REMARKS

In a non-final Action mailed 29 June2006 the Examiner raised numerous objections to the specification and drawings, mostly relating to inconsistent terminology or the failure to reproduce reference numerals throughout the specification. In addition, claim 11 was objected to for claiming, in essence, a possibility mentioned, but not described in the application. Claims 1, 3, 5, 7-9 and 11 were rejected under 35 USC, second paragraph for indefiniteness. All of the pending claims 1-13 were rejected under 35 USC Sec. 103(a) for obviousness.

I hereby certify that this **AMENDMENT UNDER 37 C.F.R. 1.111** is being deposited with the United States Postal Service as first class mail in an envelope addressed to: Mail Stop Amendment, Commissioner for Patents, P.O. Box 1450, Alexandria, VA 22313-1450 on or before 9/26/06.

FIG. 7

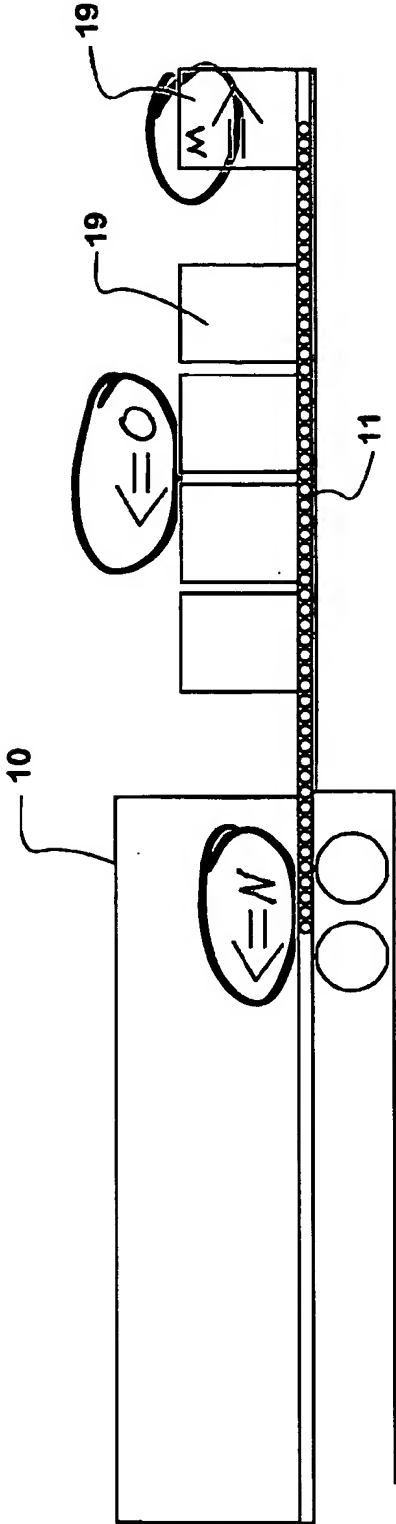
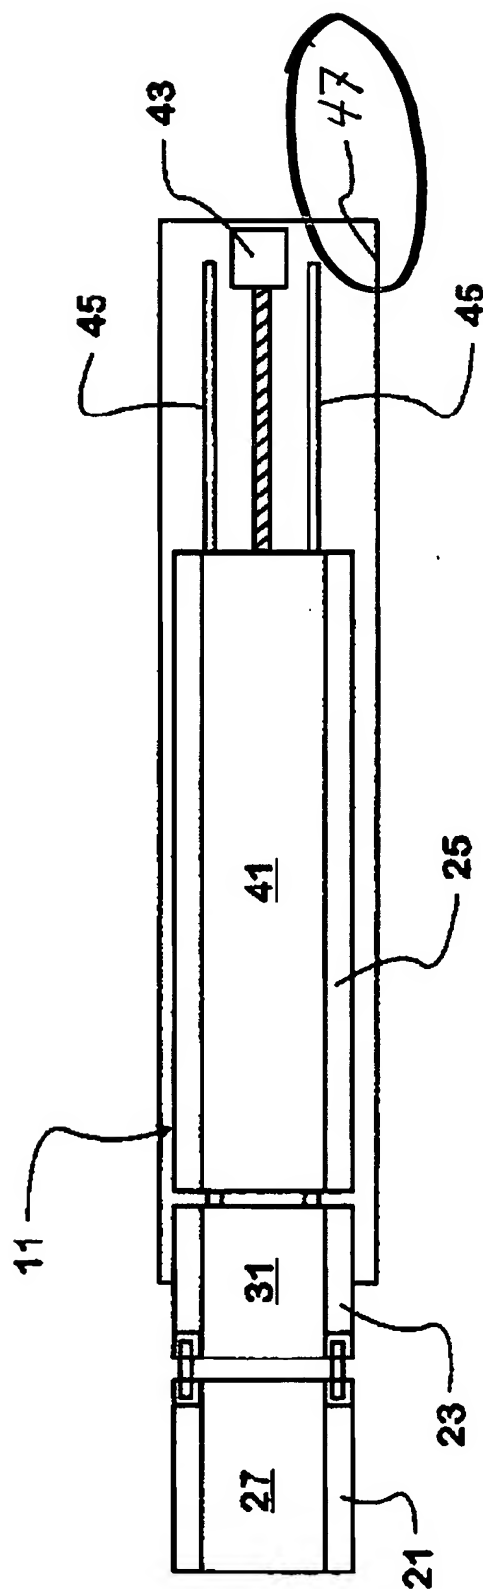
palletized freight module is called out by the letter "W". Similarly the letter "B" now refers only to a platform position. Rotation of the end segment is referred to by the letter "I". "N" has replaced "B" in Fig. 7 to indicate the direction of withdrawing the platform into a trailer. The step of Fig. 11 is redesignated "R". The freight module formerly referenced as "B" is now referenced by "X". Regarding the letter "C", its use in Fig. 11 to refer to a step has been changed to "S" and the freight module is now "Y". Use of the letter "D" in Fig. 11 to refer to a freight module has been changed to "Z" and to a step in the Figure to "T". Step "E" in Fig. 11 has been changed to "U".

FIG. 11

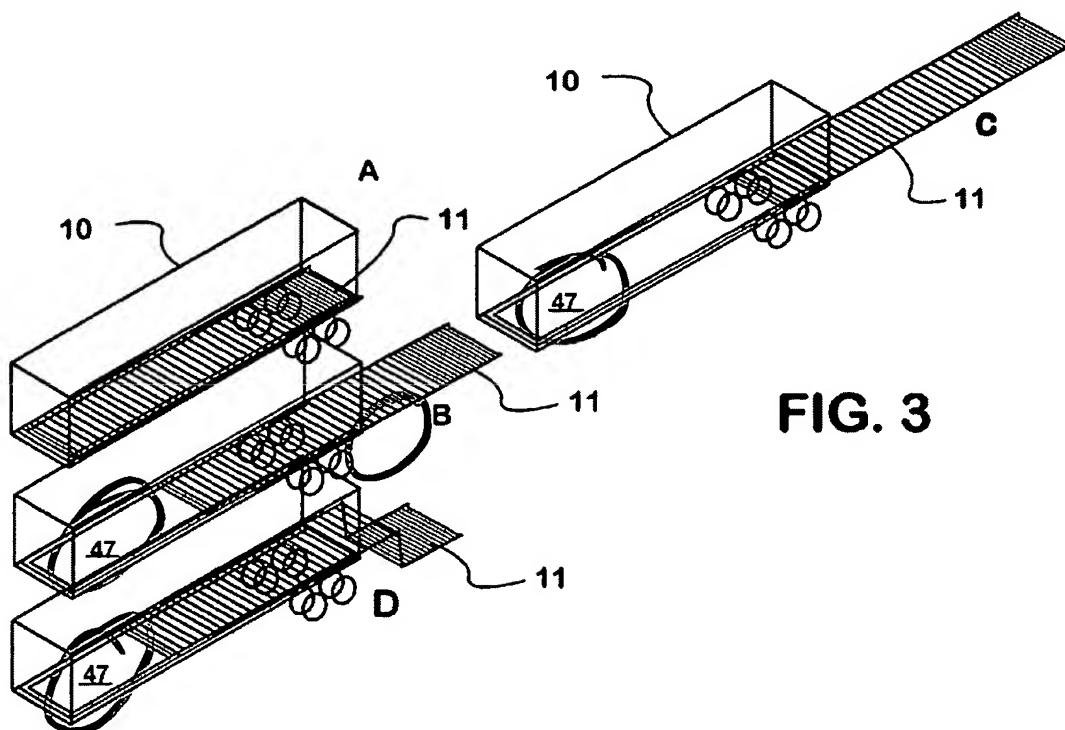
Regarding paragraph 2 of the Action, the reference numeral "13" now only refers to a target surface. The letter "A" now refers only to the retracted position of the bed. Rotation of the mid-section is referenced using the letter "H". The step of Fig. 11 formerly designated using the letter "A" is now called out by the letter "Q", and the
